**2011 Reconnaissance Level Assessment of Fish Ladders
at The Dalles, John Day and McNary Dams for
Upstream Passage of Adult Pacific Lamprey**

FY 2011 Annual Report

FINAL
November 12, 2014

Figure 13. The Dalles East fish ladder junction pool. a. Watered up. b. Dewatered. Image a by D. Benner. Image b by USACE.

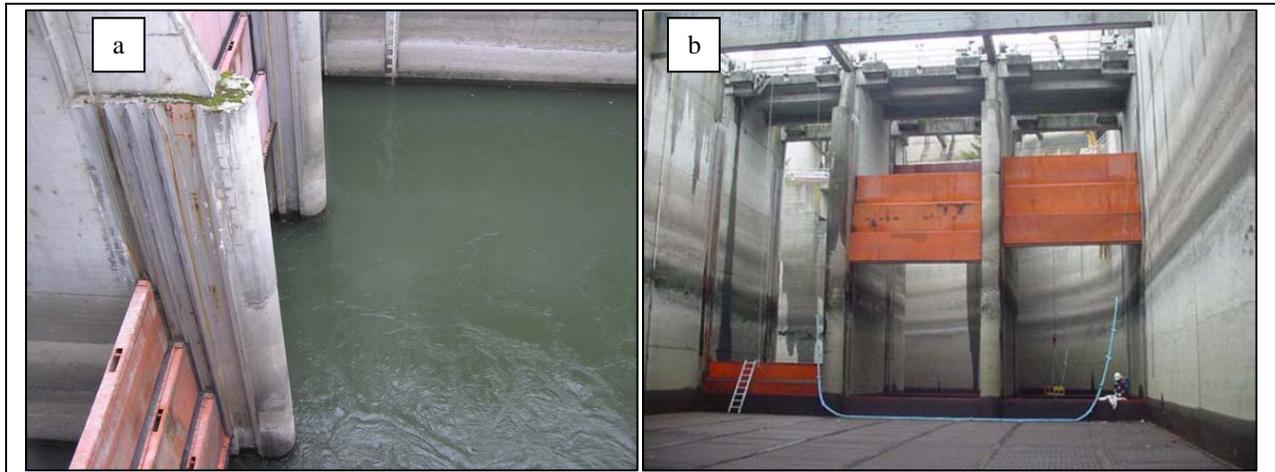
OB- It had already been identified that either adding lamprey orifices at the bottom of the concrete stub wall on the far right in Figure 13b (East ladder entrance), or removing it, would likely benefit lamprey passage over this 90° corner. (SS, HR, ST)

Figure 15. The Dalles East fish ladder. a. Turning pool 1, looking upstream. b. End of turning pool 2, the count station is above the weir. Image a by D. Benner. Image b by G. Fredricks.

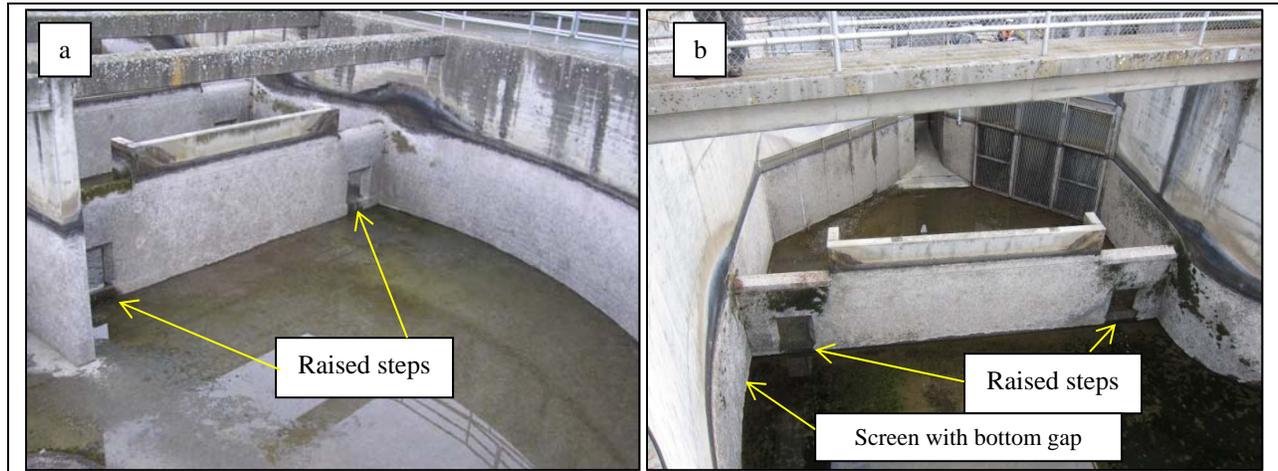
The bottom orifices at both turning pools in the East ladder (Figure 15) are stepped up above the floor of the ladder and present a 90° bend for lamprey to navigate.

OB, C- Install ramps to provide better attachment and passage for lamprey. (SS, HR, ST)

OB, C- Diagonal screened enclosure should have gap at the bottom reduced.

Based on these observations above ramps were installed at orifices in both turning pools (Figure 16) in January 2012 during the winter work period.

Figure 18. The Dalles East fish ladder. Removable flow control weir with orifice located upstream of the count window. a. Downstream face. b. Upstream face. Image a by D. Benner. Image b by G. Fredricks.

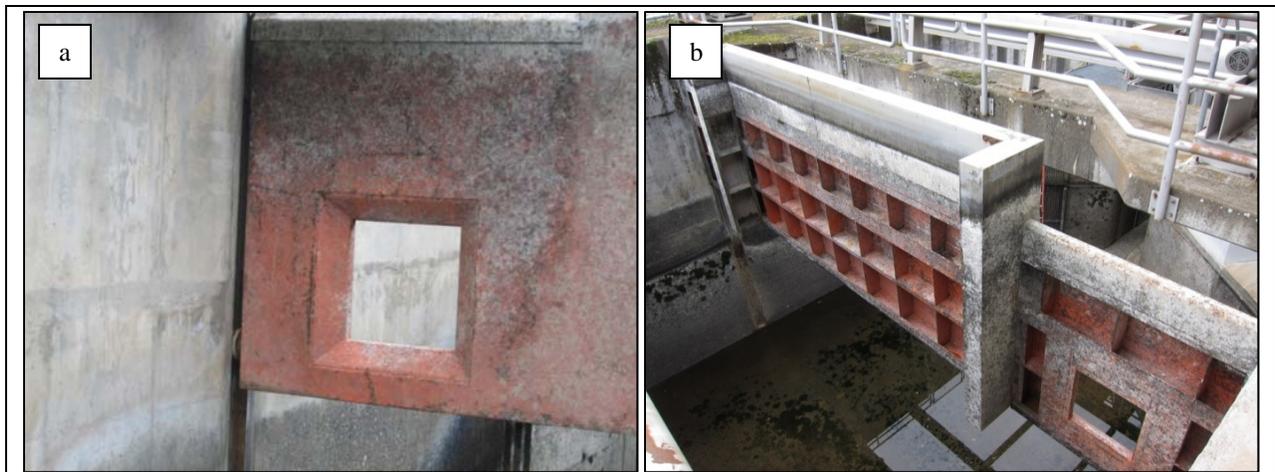
OB, C- Install ramps on downstream face to provide better attachment for passage. (SS, HR, ST)

Figure 19. The Dalles North fish ladder entrance. Image by D. Benner.

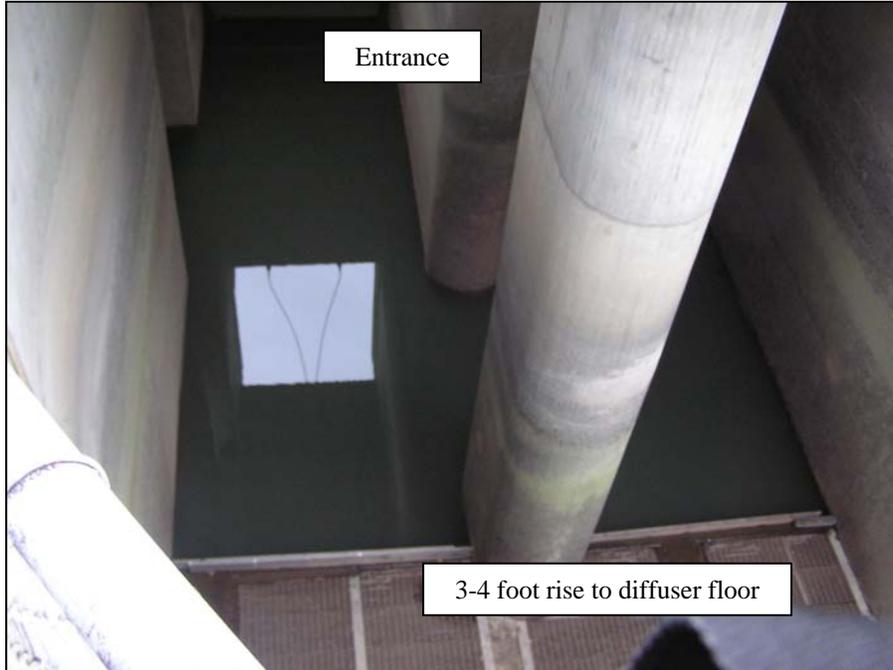
The floor of the fishway entrance rises straight up approximately three to four feet as it meets the diffuser floor. This is about a 40 foot distance (Figure 19).

OB, C- Possible location for lamprey ramps.

Figure 28. John Day South ladder. a. Overflow weirs with bottom orifices. a. Expansion joints in the ladder.

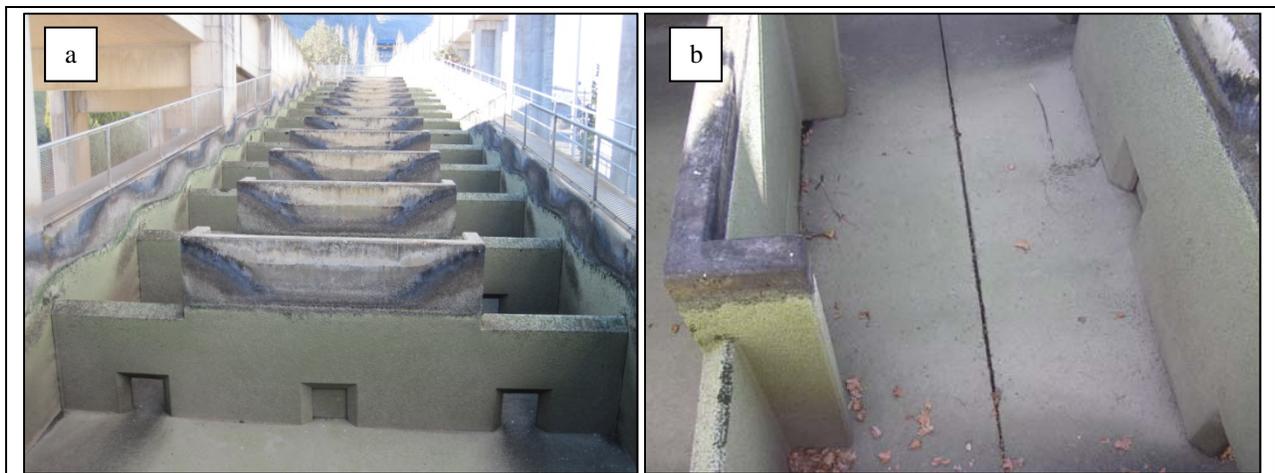
OB, C- The expansion joints in the high velocity areas could be filled and smoothed to provide an uninterrupted pathway between orifices. (SS, HR, ST)

Figure 34. The McNary South ladder count station. a. Slot entrance. B. Slot exit. Image a. by USFWS. Image b. by D. Benner.

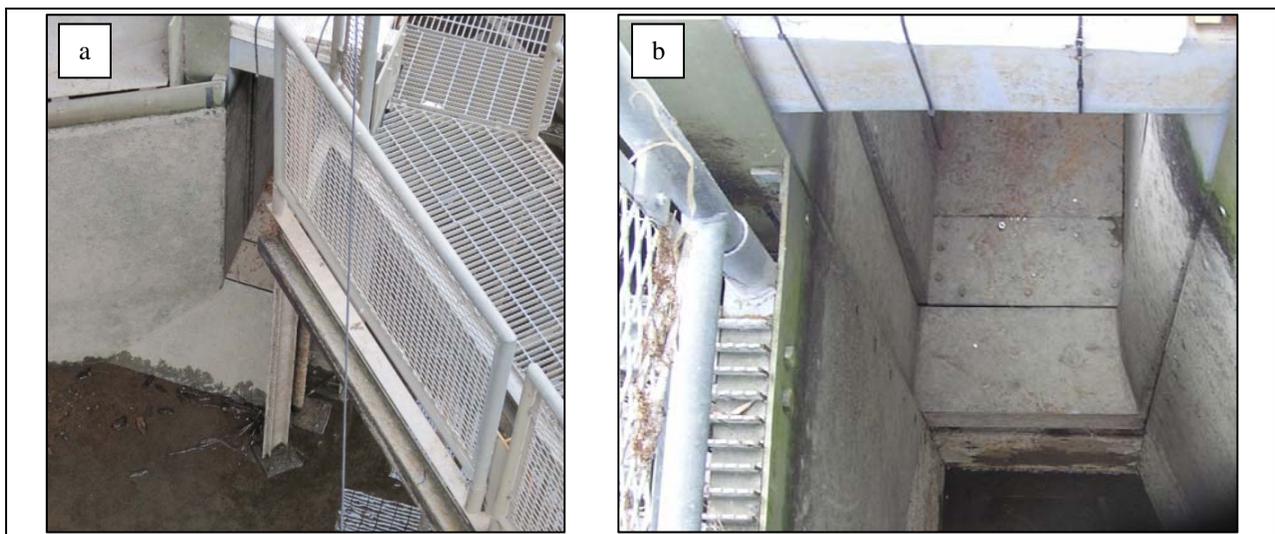
The McNary South ladder count station slot entrance is ramped and sides are smoothed (Figure 34a). The exit end of the slot has a sharp drop, with mostly smooth, solid sides (Figure 34b), but some gaps exist.

DN, C- Flow velocities and directions should be determined in the area where the exit slot deeply drops off to assess impacts to lamprey. Ramping the end may be needed. (SS, HR, ST).

Figure 36. McNary South Ladder immediately upstream of count station. a. One foot high stub wall between count station and first tilting weir. b. Close up of small debris holes in stub wall. Image a. by USFWS. Image b. by D. Benner.

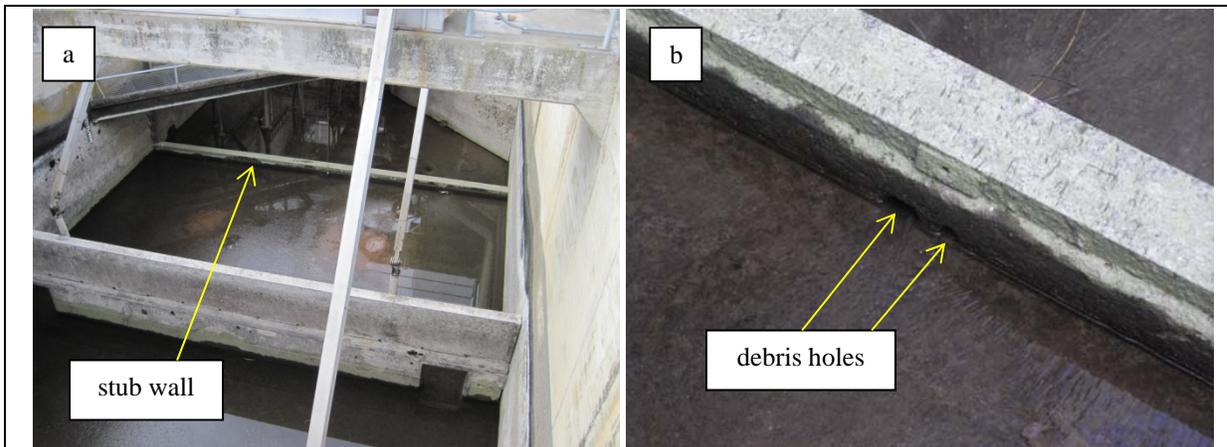
Directly upstream of the count station is a stub wall about one foot high (Figure 36). There are a few small debris orifices drilled through the bottom that are too small for adult lamprey to use.

OB, C- The stub wall should either be ramped or the small debris orifices enlarged to accommodate lamprey passage. (SS, HR, ST)

Figure 38. McNary South fish ladder exit section between the count station and the fishway exit. a. V-shaped stub wall that is approximately 2-3 feet high. b. 6 inch step down in floor elevation. Image a. by USFWS. Image b. by D. Benner.

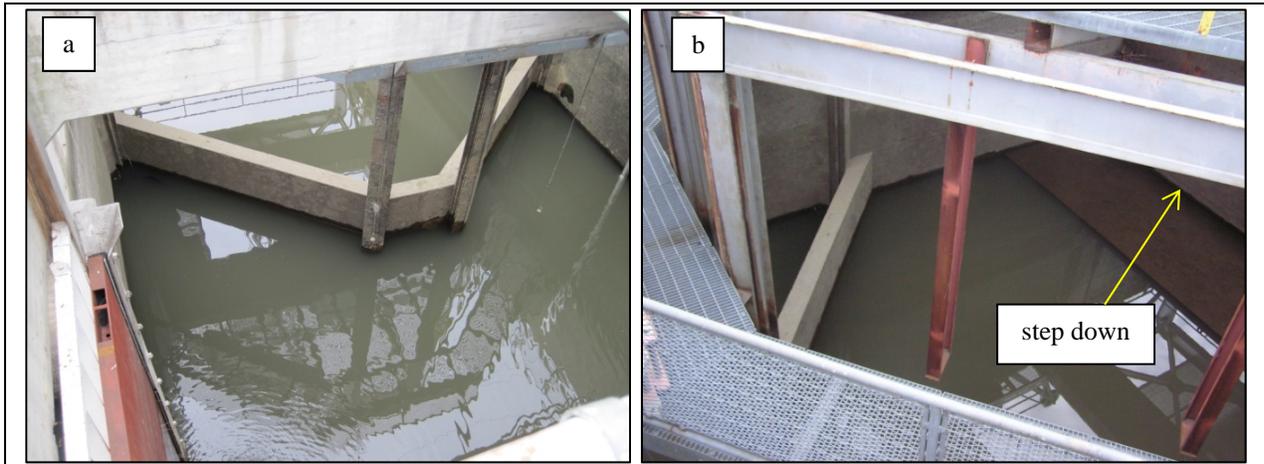
Between the last tilting weir and the fishway exit there is a V-shaped stub wall that is approximately 2-3 feet high (Figure 38). Upstream of this wall the floor elevation rises several inches to a sharp corner.

OB, C- Install lamprey passage orifices at the bottom of the V-wall. (SS, HR, ST)

Figure 40. McNary Dam North ladder, turn at the bottom of the ladder just upstream of the entrances. Image by D. Benner.

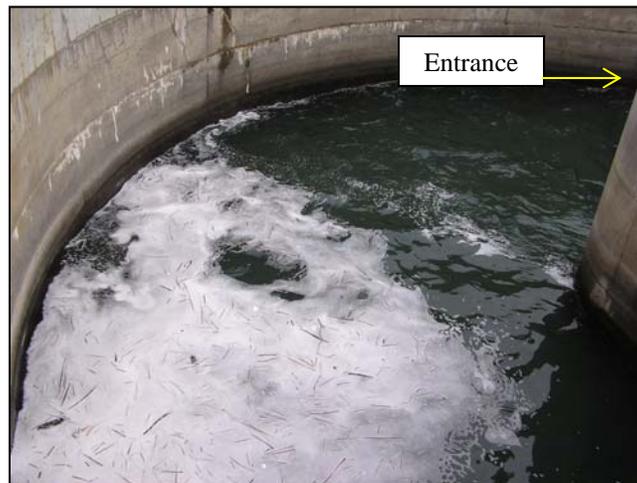
C, DN- Evaluation of this section is needed when this area of the fishway can be dewatered below tailwater. (SS, HR, ST)

Figure 46. McNary North ladder tilting weirs. a. Downstream face of weir. b. Upstream face of weir. Images by D. Benner.

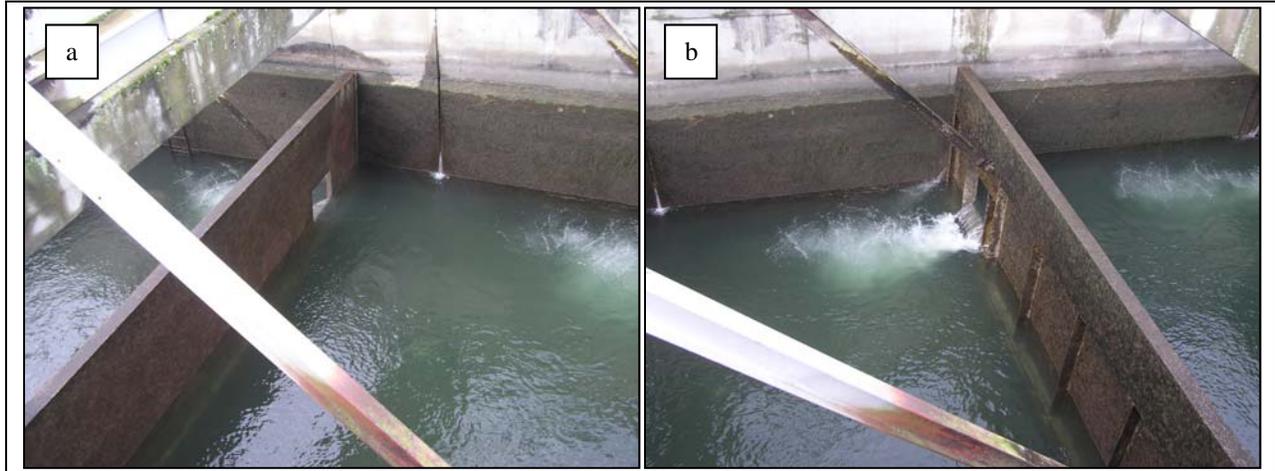
Some of tilting weir orifices are elevated from the fishway floor on the downstream side. The upstream face of the tilting weirs are mostly smooth and can provide attachment locations for lamprey (Figure 46a). The downstream faces could be plated around perimeter of orifice opening to provide smooth attachment locations for lamprey as they prepare to pass through the orifice (Figure 46b).

Ob,C- Add ramps to the elevated orifices or cut lamprey orifices through the stub walls flush with the floor of the ladder. (SS, HR, ST)
